# **Proposal Request**

Polk Stanley Wilcox 509 W. Spring St., Ste 150 Fayetteville, AR 72701 Architect's Project Number: 993A Proposal Request Number: 089R Proposal Request Date: 03.06.2025

# PROPOSAL REQUEST 089R

# Green Roof Devices and High Roof Security Cameras Ver. 2

GREEN ROOF DEVICE ELEVATIONS

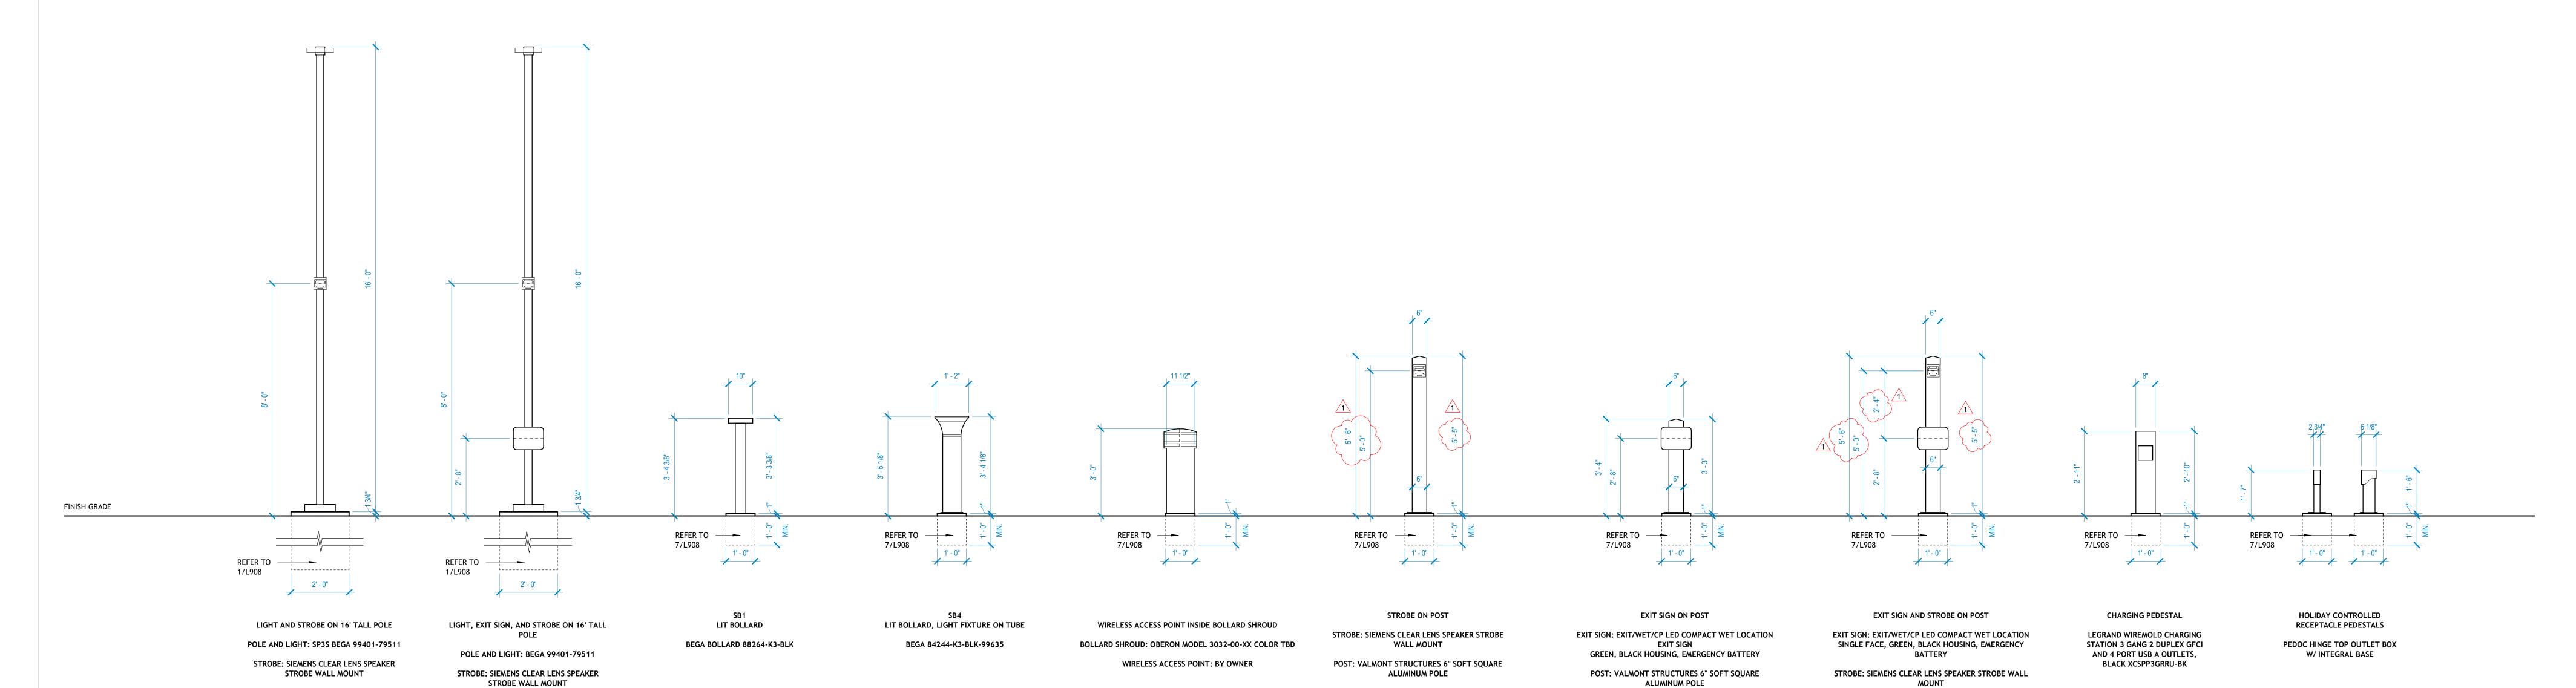
- a) Refer to Revised Sheet **A940**, with original issue date 12.12.2024 (PR.089) and revised date 03.06.2025.
  - Legend added elevating rooftop devices.
  - Heights of Strobe on Post and Exit Sign and Strobe on Post modified.

ELECTRICAL SITE PLAN - ROOF

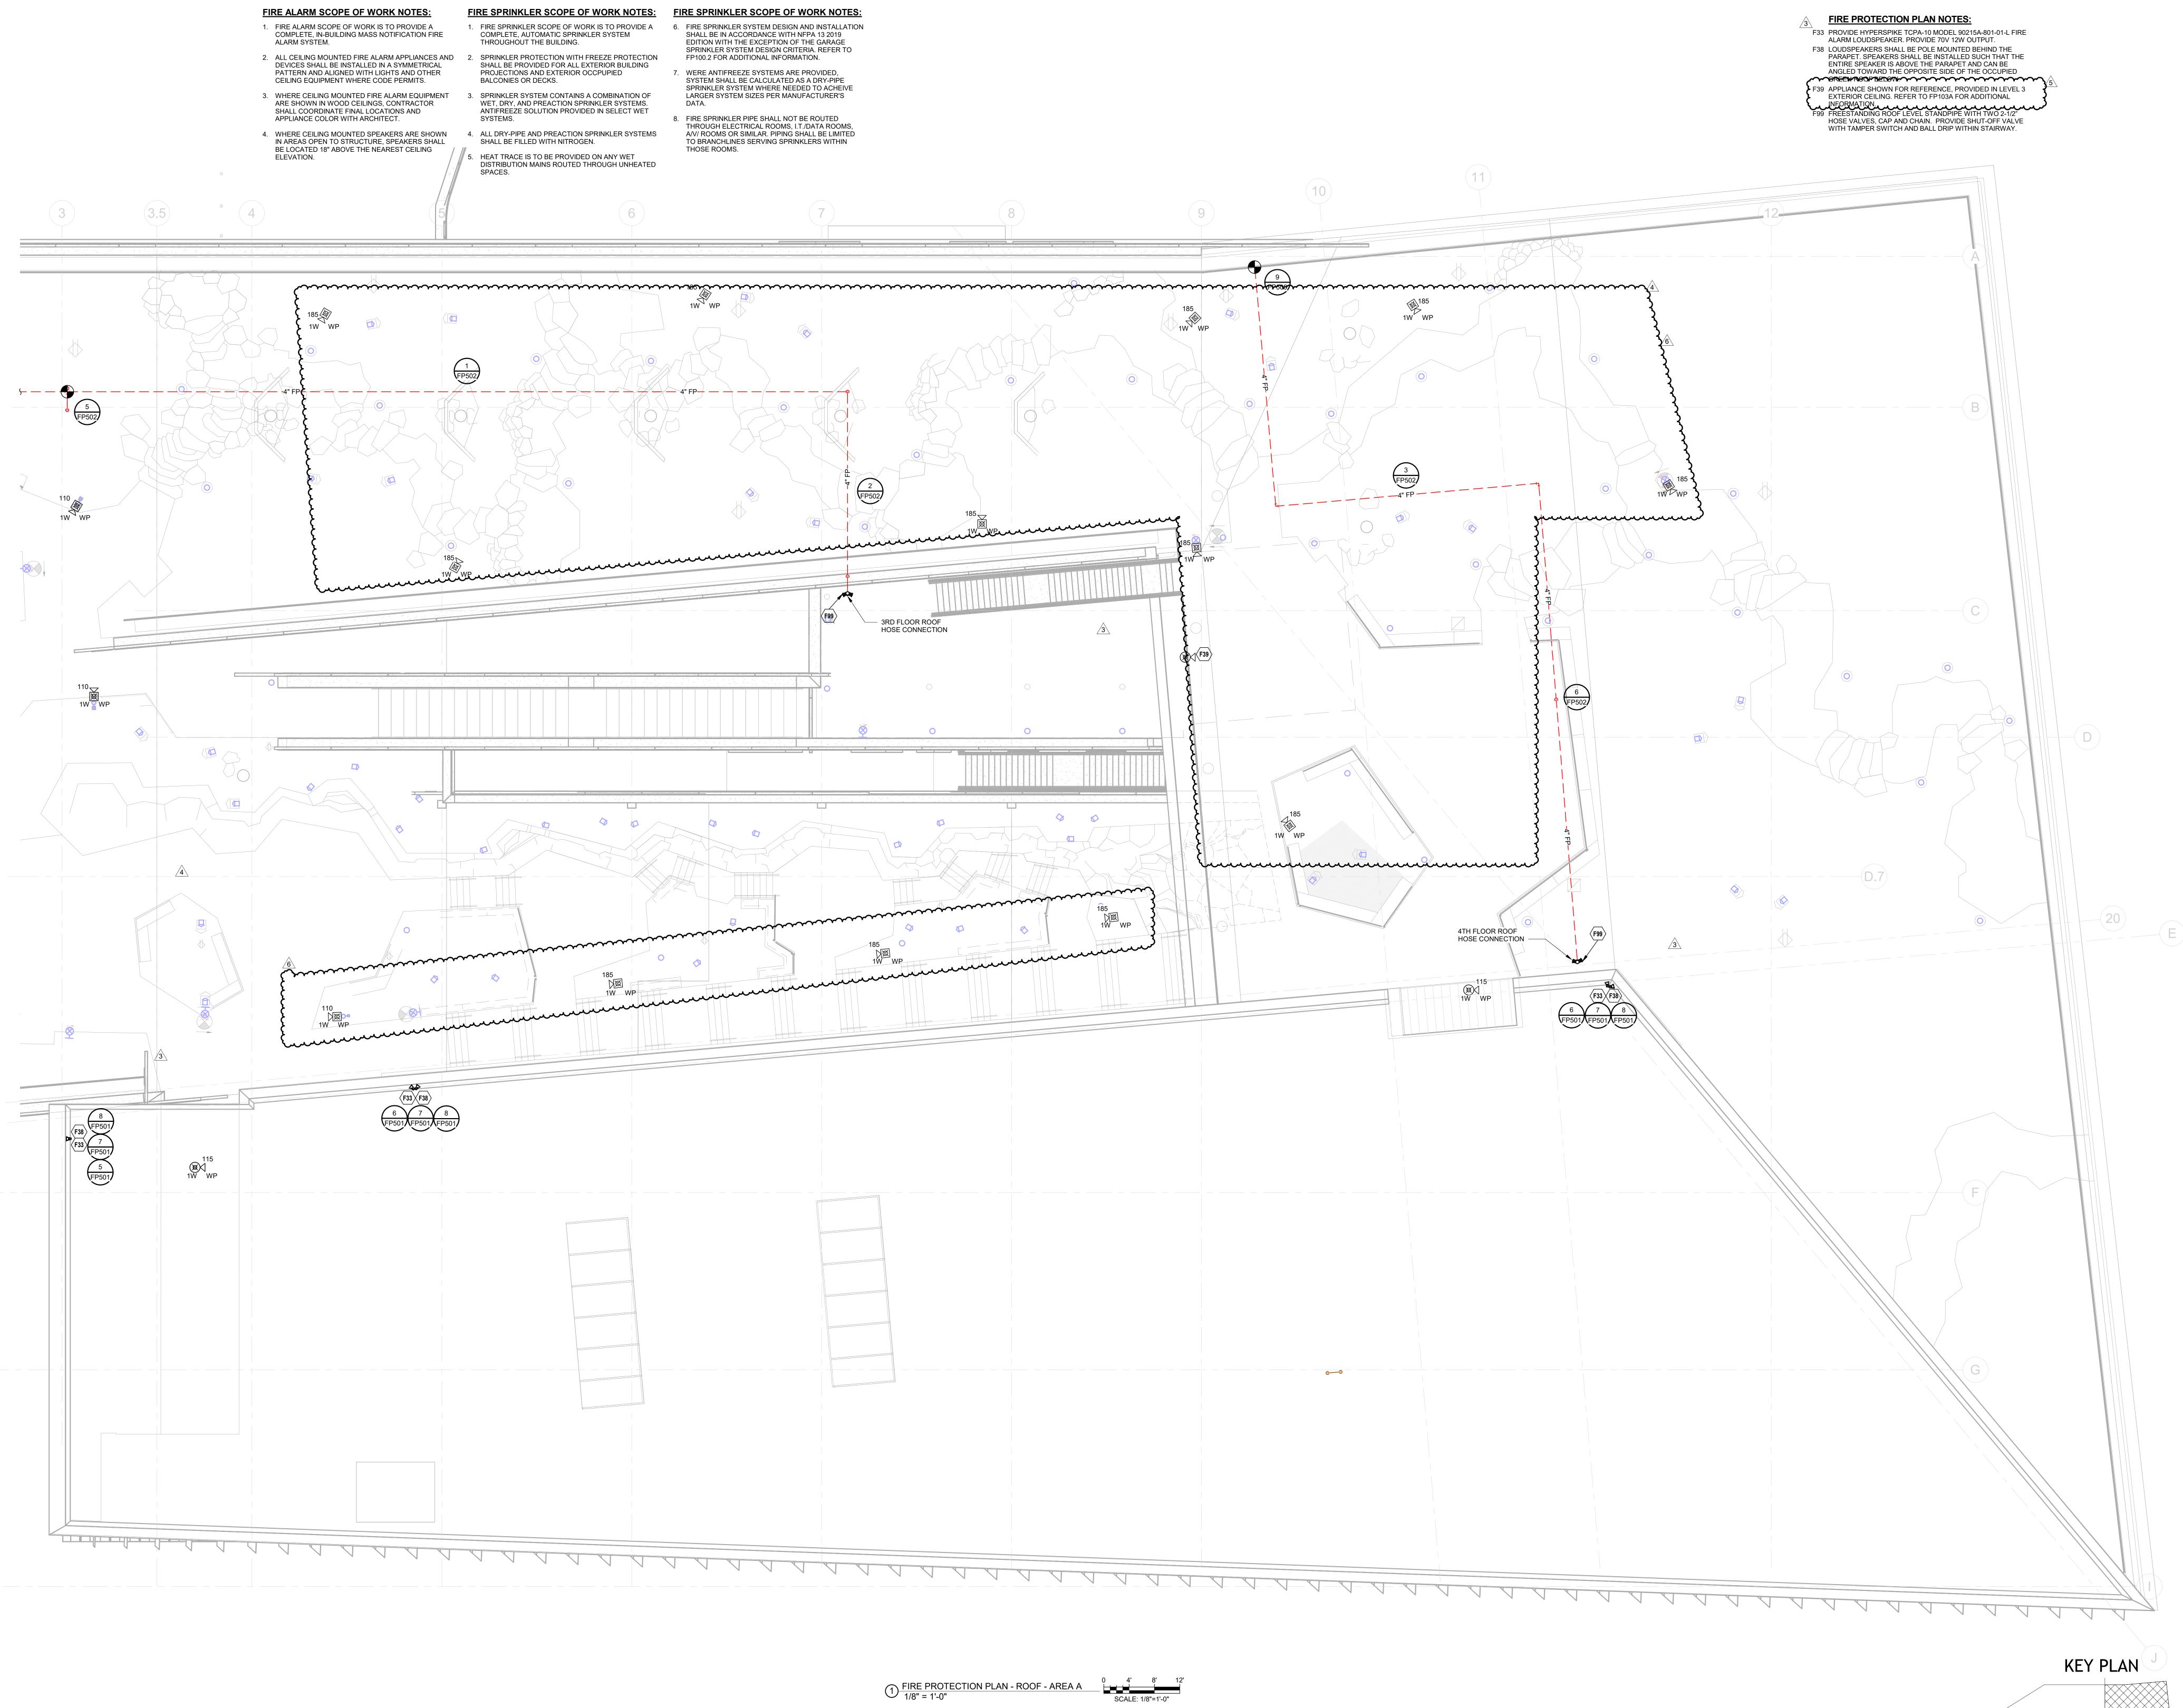
- a) General clarification: For all charging pedestals and precise dimensions for locations of devices, refer to landscape plans. The revisions indicated below are intended to identify significant location changes.
- b) Revised Sheet **E100.2**, Detail 1, with original issue date 02.24.2023 and revised date 03.06.2025.
  - To align with landscape coordination:
    - (1) Adjust location of two type SB4 light fixtures.
    - (2) Adjust location of one XWB2 fixture.
    - (3) Adjust location of one type H holiday receptacle pedestal.
- c) Revised Sheet **E100.2**, Detail 2, with original issue date 02.24.2023 and revised date 03.06.2025.
  - To align with landscape coordination and RFI 525:
    - (1) Remove exit sign on level 3 plaza.
    - (2) Adjust location of fixture SB4.

FP105A

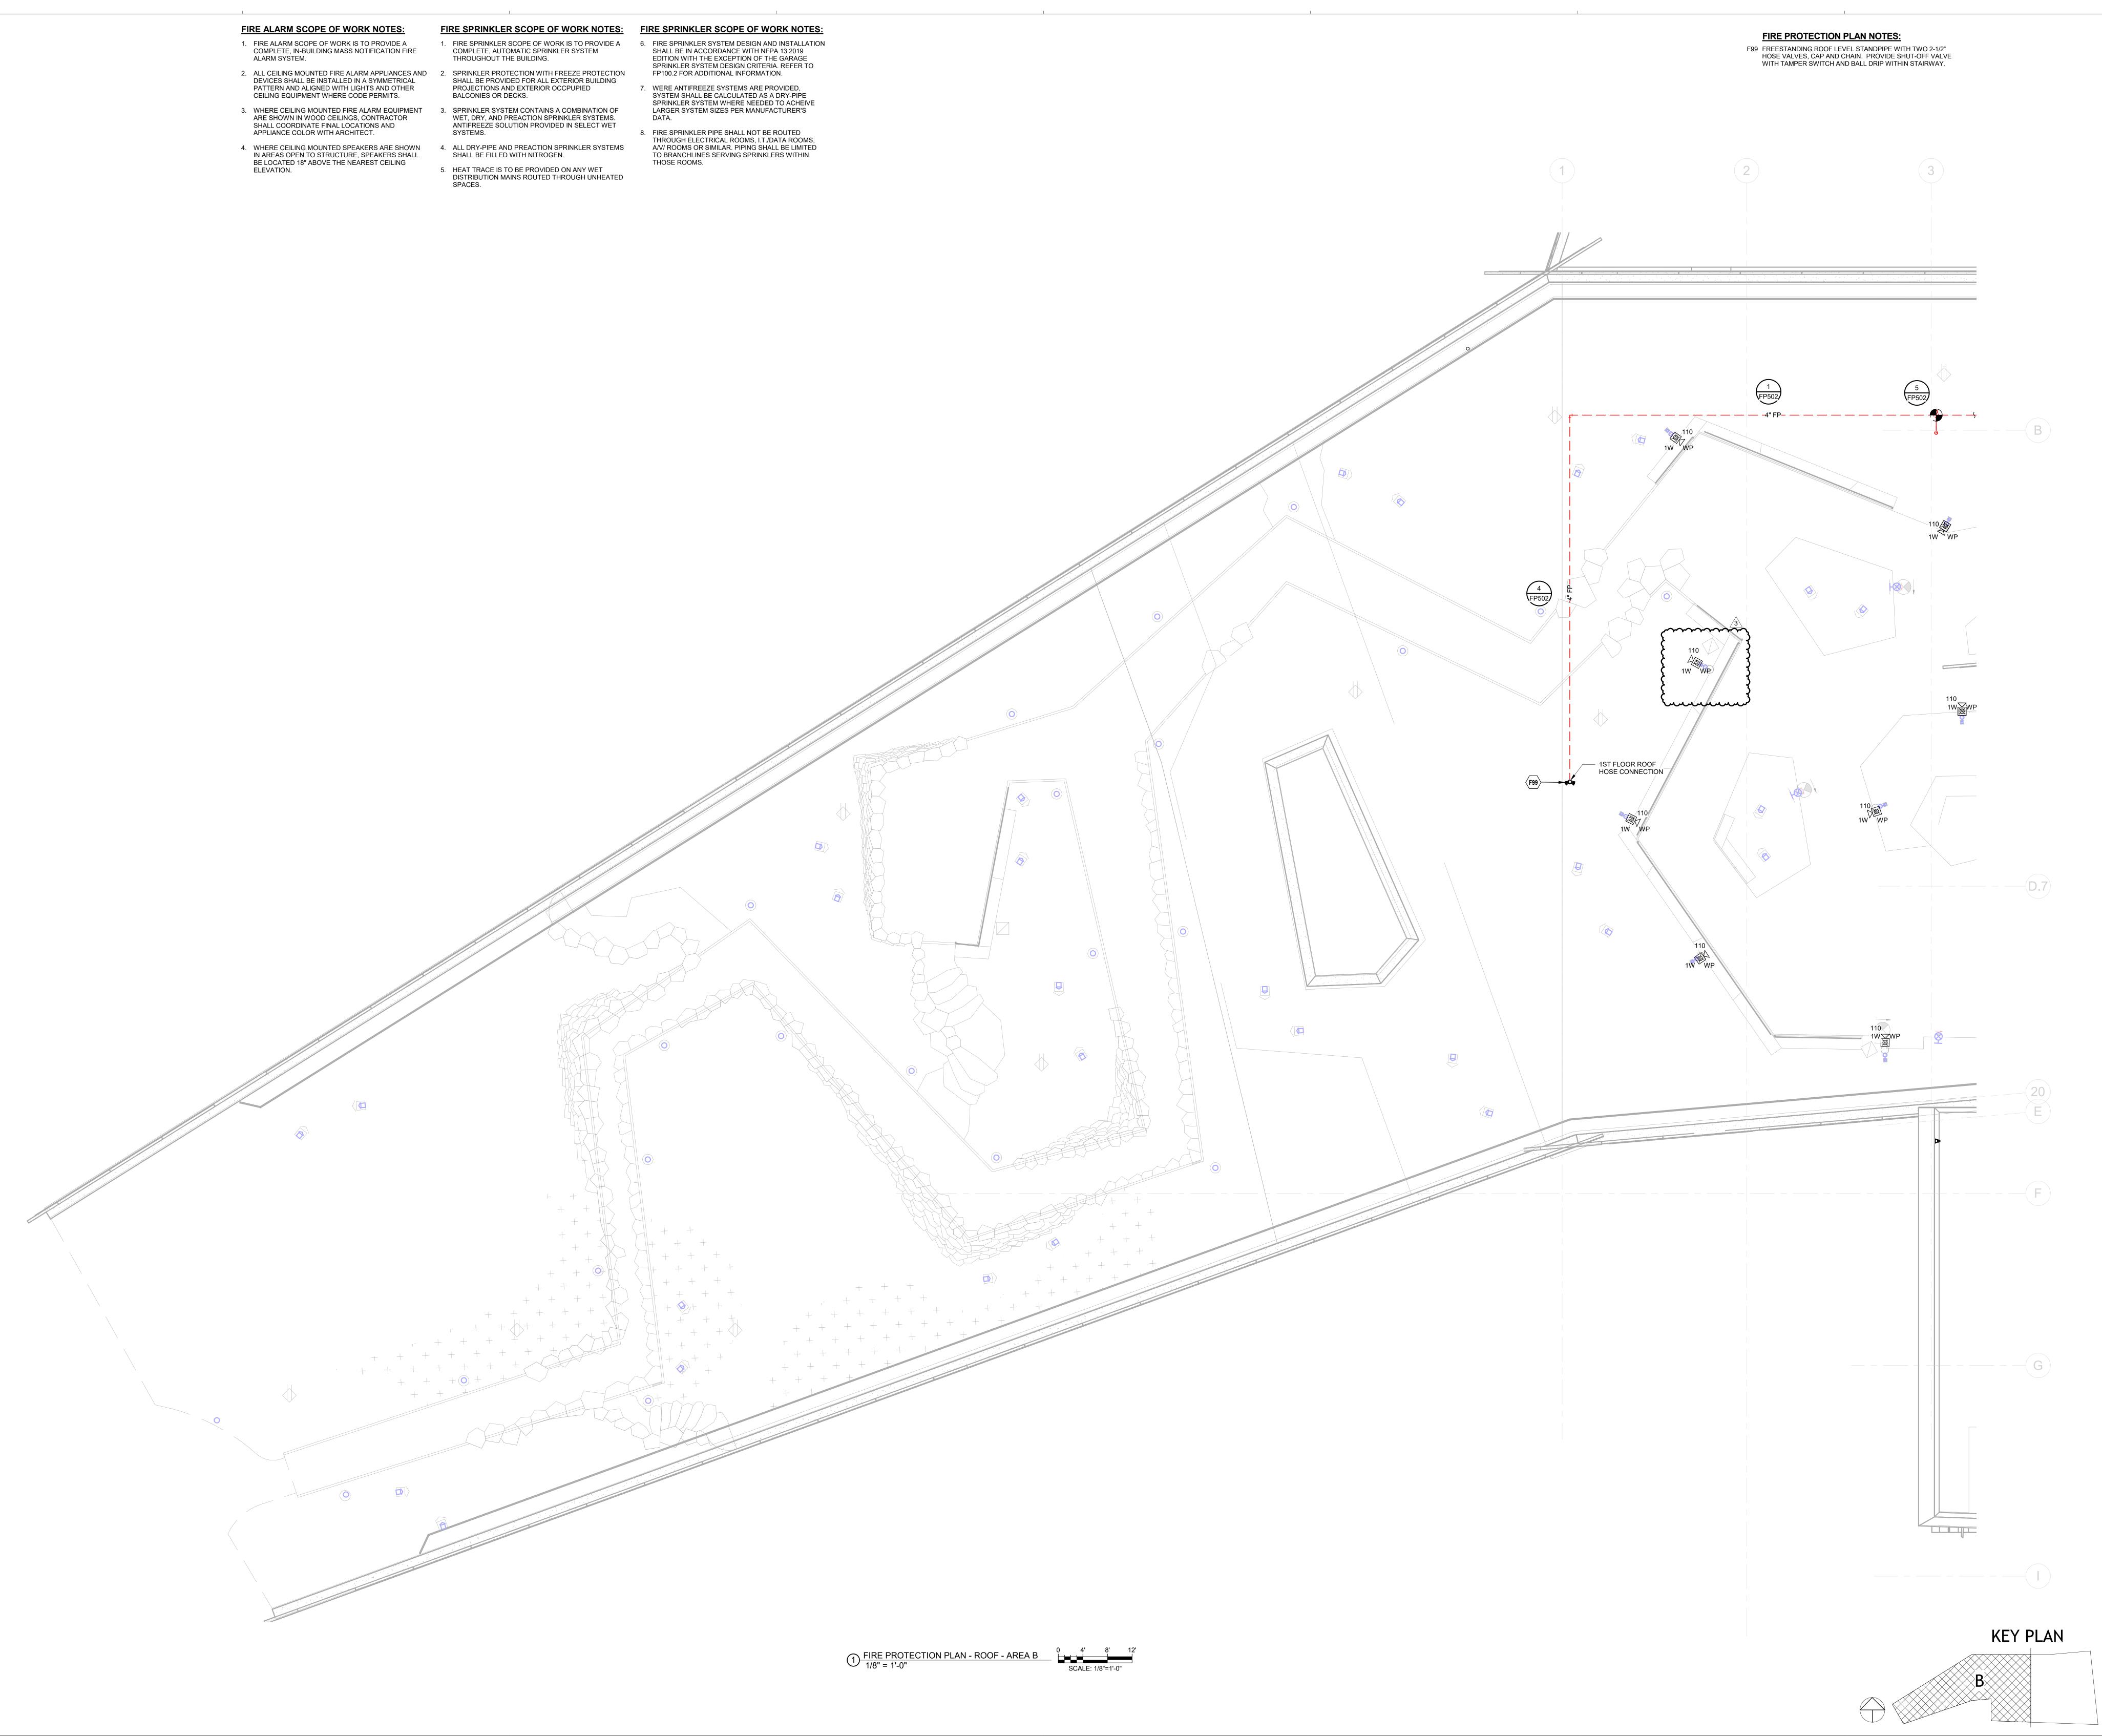
- Revised Sheet FP105A, Detail 1, with original issue date 02.24.2023 and revised date 03.06.2025.
  - To align with landscape coordination:
    - (1) Adjust location of 15 fire alarm appliances.
    - (2) Remove 1 fire alarm appliance.
- b) Revised Sheet **FP105B**, Detail 1, with original issue date 02.24.2023 and revised date 03.06.2025.
  - To align with landscape coordination:
    - (1) Adjust location/orientation of 1 fire alarm appliance.
